Access Compliance Report

Public Rights-of-Way

(Curb Ramps)

Intersection ID: 48476	Main Street: FERNLEDGE_CT	Cross Street: AUTUMN_OAK_DR	Location: W
ADA ID: CC78E0E72E82	Ramp Type: Perp	Initial Pass/Fail: Fail	Overall Compliance: No
Severity Score: 33.75			
Codes/Mitigation Info/Possible Solution		Field Measurements/Component Compliance

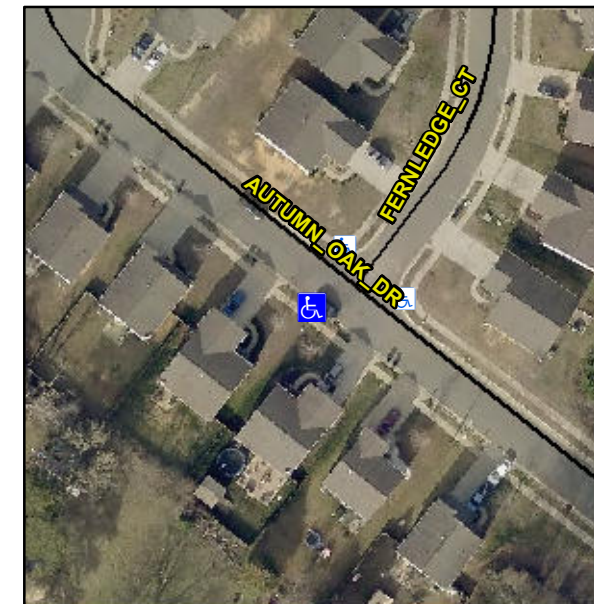
Not Found, R304.5.1, R304.2.2

Compliance	Description	Data	Compliance	Description	Data
N/A	Ramp Length (in)	48.0	No	Ramp Slope (%)	16.9
No	Ramp Width (in)	47.5	Yes	Ramp XSlope (%)	1.6
N/A	Flare Type LT	N/A	N/A	Flare Type RT	N/A
N/A	Flare Slope LT (%)	N/A	N/A	Flare Slope RT (%)	N/A
N/A	Flare Traversable LT?	N/A	N/A	Flare Traversable RT?	N/A
N/A	Landing Length (in)	N/A	N/A	DWS Provided?	N/A
N/A	Landing Width (in)	N/A	N/A	DWS Contrast?	N/A
N/A	Landing Slope (%)	N/A	N/A	DWS Length (in)	N/A
N/A	Landing X Slope (%)	N/A	N/A	DWS Full Width?	N/A
N/A	Landing Curb? (Y/N)	N/A	N/A	DWS Offset (in)	N/A
N/A	Shared Landing?	N/A			
N/A	Gutter Ponding?	N/A	N/A	Gutter Slope (%)	N/A
N/A	Gutter Lip Ht (in)	N/A	N/A	Gutter X Slope (%)	N/A
N/A	Painted X Walk1?	No	N/A	Painted X Walk2?	N/A
	X Walk 1 Direction	To NE		X Walk 2 Direction	N/A
N/A	X Walk 1 Width (in)	N/A	N/A	X Walk 2 Width (in)	N/A
	X Walk 1 Slope (%)	2.9		X Walk 2 Slope (%)	N/A
	X Walk 1 X Slope (%)	2.2		X Walk 2 X Slope (%)	N/A

Remove & Replace Entire Ramp.
